Development Review Committee
May 17, 2023
Council Chambers
9:00 AM

**DM WAIVER REQUEST
281 Circle Drive
DEVELOPMENT REVIEW COMMITTEE (DRC)
MAY 17, 2023**

APPLICANT:	Rob Smith, E2; PO Box 3300, Winter Park, FL 32790
OWNER(S):	E2H 281 CIRCLE LLC, PO Box 3300 Winter Park, FL 32790
PETITION:	Waiver requests related to proposed renovation of building.
PROPOSED USE:	Professional Office/ Contractors' Office
DISTRICT:	Downtown Maitland
FUTURE LAND USE:	Main Street
LOCATION:	281 Circle Drive
PARCEL ID(S):	36-21-29-9408-00-190
ACREAGE:	0.17 acres
ACCESS:	Circle Drive

P.O. BOX 3300, WINTER PARK, FL 32790 P: (407)9133246	
PROPOSED SITE	
E2H 281 CIRCLE DR	
DATE: 09/01/2021	
SCALE: 1/16"	SHEET: 2/4

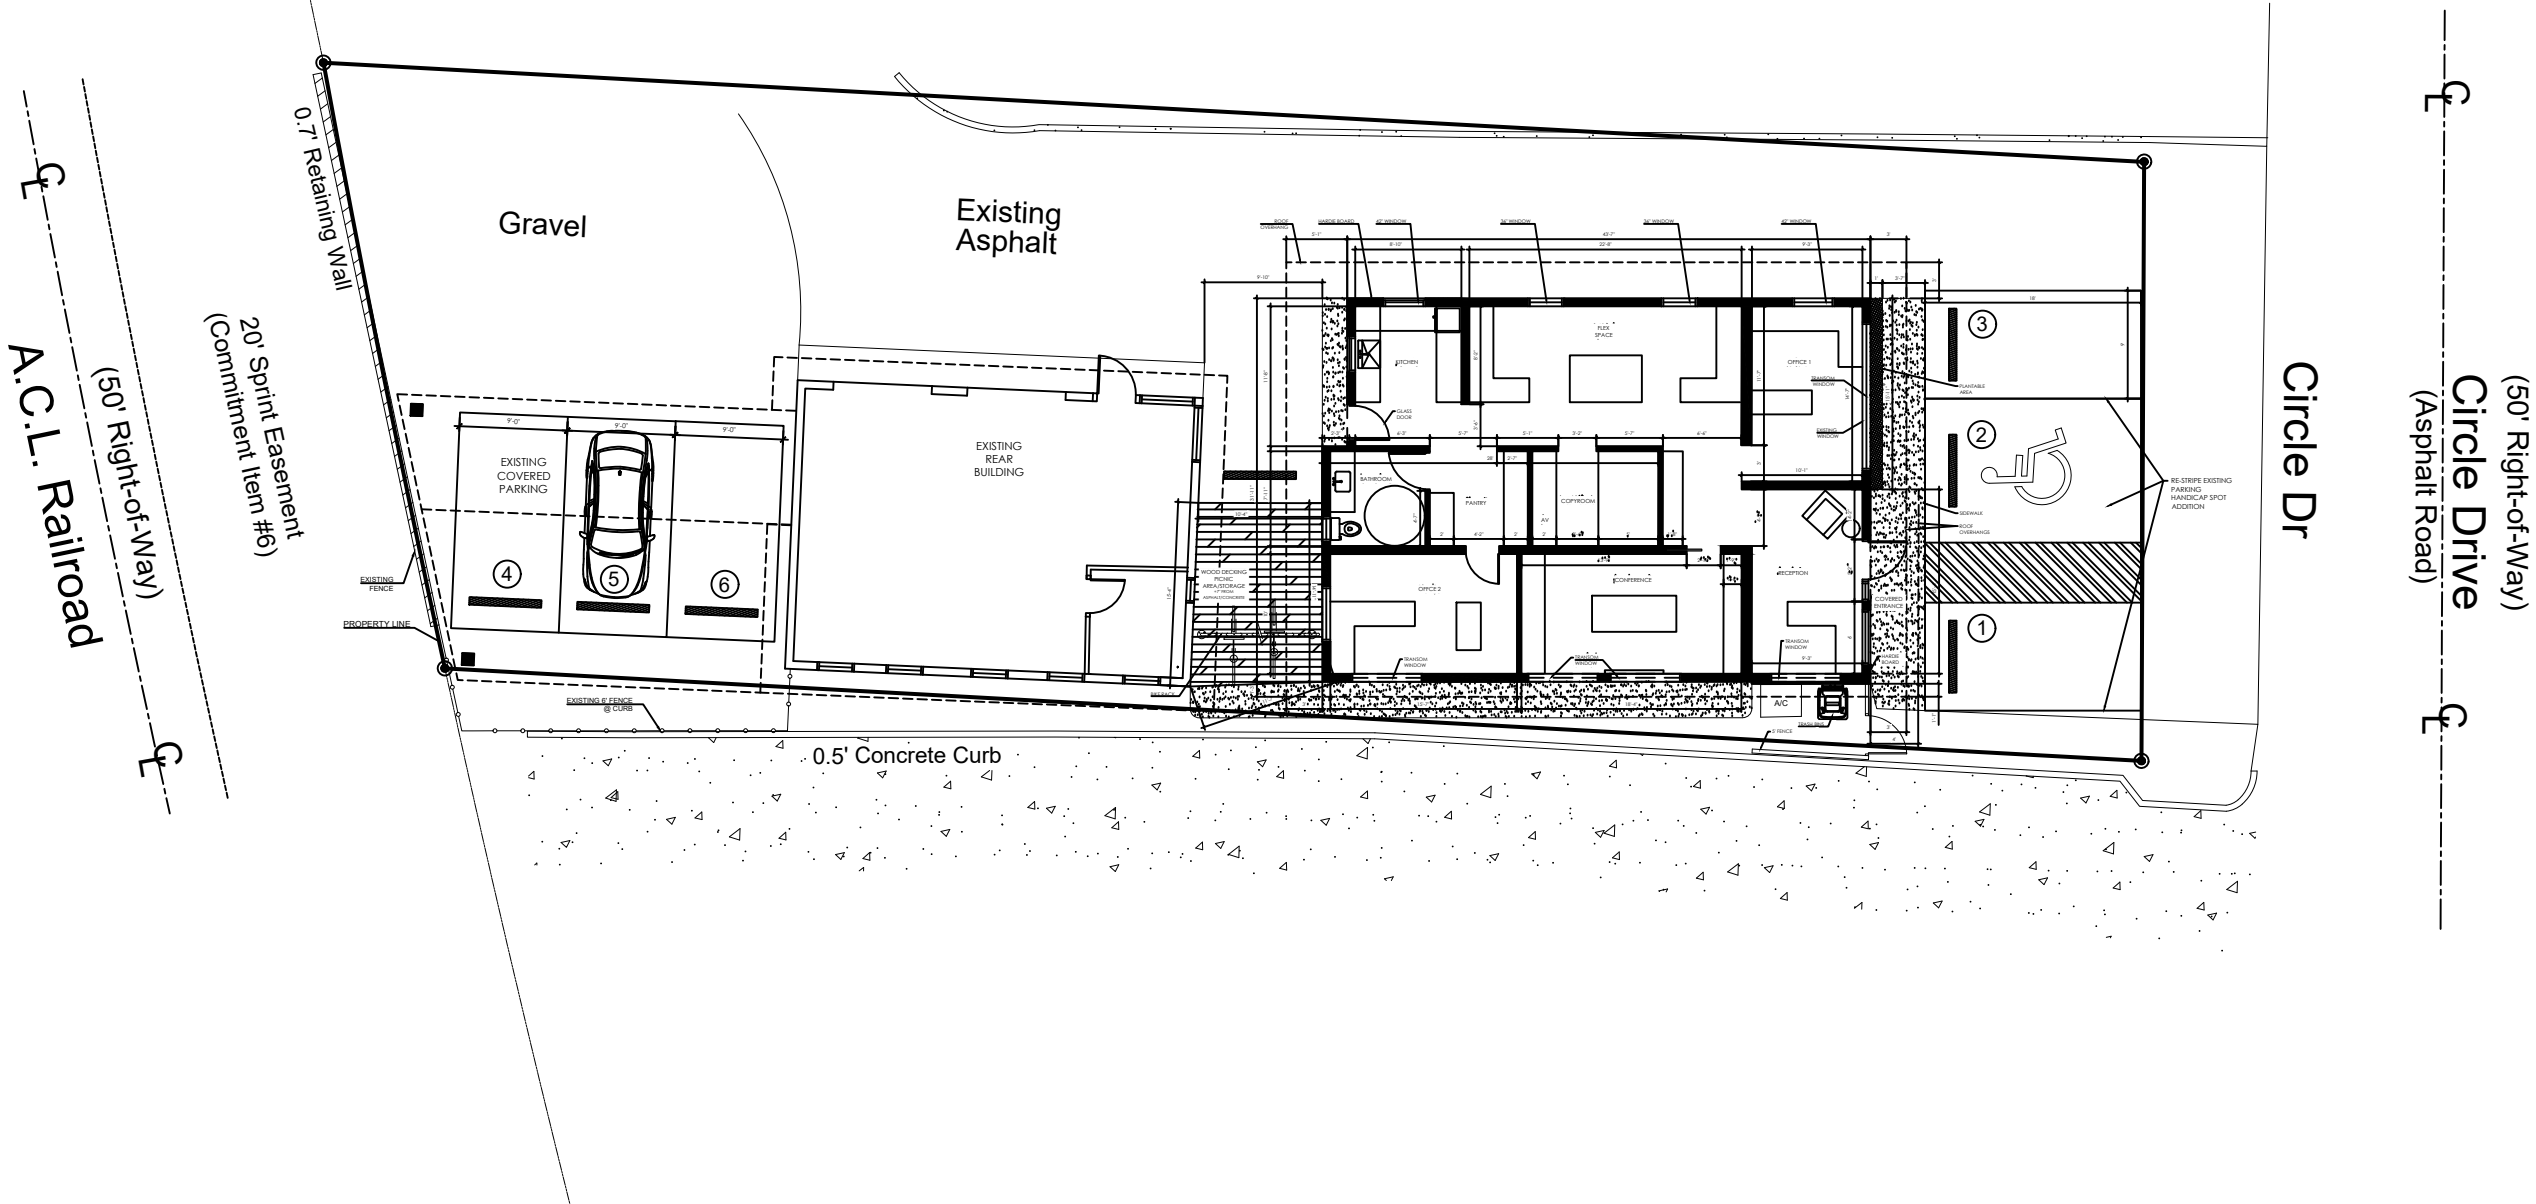
The proposed parking lot location creates conflict between pedestrians and vehicular access. Parking should not have any stalls that back into the right of way. If a handicap accessible parking stall is required, it can become a parallel spot that does not back into the right of way, and would not require a waiver from *Sec. 3.3.5(e)(7) Parking Lot Location*.

The existing width of the drive aisle does not meet minimum engineering standards for two-way traffic. Existing cross access, which is proposed to remain, appears to meet the standard of subsection (B) so a waiver would not be needed.

Staff finds that this standard has not been met.

Staff finds that the proposed waiver of DM standard *Sec. 3.3.5(e)(7) Parking Lot Location* does not meet the review standards established in *Sec. 2.5.4(b) (4)*.

Waiver Denied____X_____

Based on these justifications, the Project Proposal (shown below) is submitted for waiver approval.

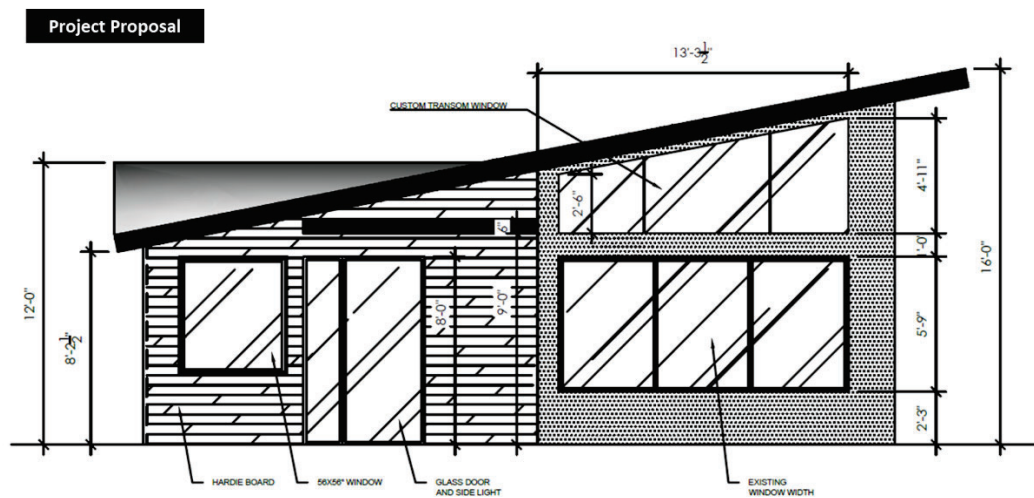
Justification: It is not feasible to fully comply with this standard in a modest remodeling project, however, our waiver request aims to partially achieve the standard (see the elevation drawing of the remodel shown below). The right side of the building reaches a 14 feet ceiling height and a roof height of 16 feet. The street view while moving along Circle Drive will be of a modernized office building façade and the pitched metal roof - instead of the dated 1945 residential structure that greets you today (shown further below). The remodeled design creates a volume roofline over a portion of the building which adds visual interest from the street and smartly prepares the building for optimal solar energy production (net zero energy goal). In addition, this remodel contributes to a modern and attractive design aesthetic for Circle Drive which began with earlier E2 developments at 301 Circle Drive and 323 Circle Drive.

The adjacent and surrounding buildings are all one-story structures of similar age. The proposed project helps to retain the scale of the street, while still modernizing. In fact, making the structure fully compliant to the 14 ft ceiling height requirement could make the property feel out of scale on this street. It is also noted that 301 Circle Drive was permitted and remodeled with a similar design aesthetic, just a few years ago. This project produces no negative effects on health, safety, and welfare of the public, but does improve all three for the building occupants.

Staff finds that the proposed waiver of DM standard *Sec. 3.3.5(e)(4) Public Frontage Standards* meets the review standards established in *Sec. 2.5.4(b) (4)*.

Waiver Approved X

Based on these justifications, the Existing Subject Property (shown below) is submitted for waiver approval.

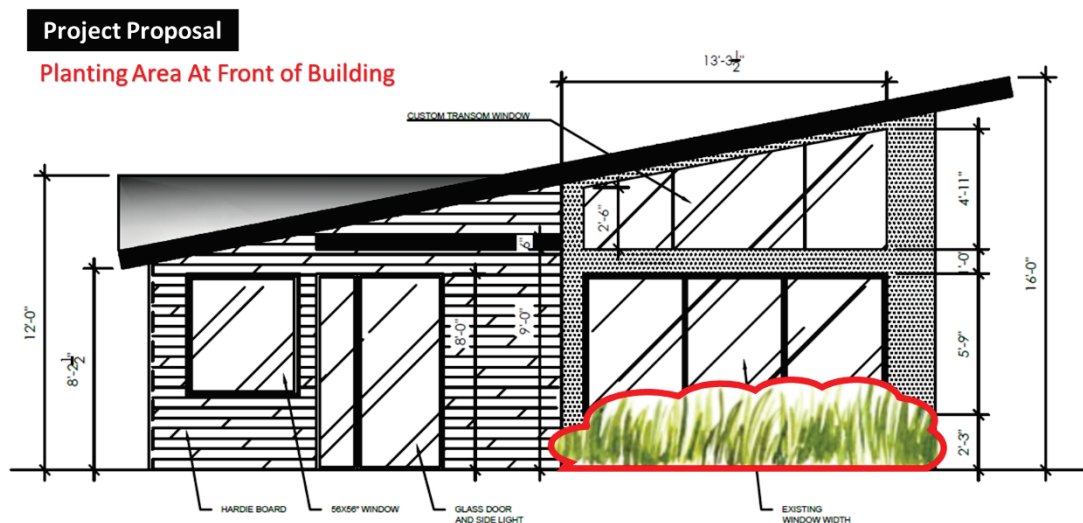
Justification: The subject property is currently non-conforming to tree requirements (it should be noted that neighboring properties meet or exceed the tree requirements, suggesting compliance at the street level). The existing building layout, parking areas, train rail buffer, and perimeter screening features do not support the addition of new trees without reducing compliance in other areas. It may be possible to consider adding one tree at the southwest corner of the subject property (left side of street frontage). However, the addition of one tree would not achieve compliance (as two new trees would be required based on lot size) and that tree could conflict with the project's plan for achieving net-zero energy status through rooftop solar power production for the building - a continuing trend for Circle Drive projects developed by E2.

The project proposes to introduce a new planting area along the front of the remodeled building (illustrated below). This planting area will 'green' the street view and will not restrict the achievement of parking compliance. In addition, the southwest corner of the subject property is planned to be 'greened' with district appropriate plantings, consistent with the property boundary between 301 Circle Drive and 291 Circle Drive (illustrated below).

Staff finds that the proposed waiver of DM standard *Sec. 3.3.5(e)(10) Landscaping and Screening* does not meet the review standards established in *Sec. 2.5.4(b) (4)*.

Waiver Denied ____X____
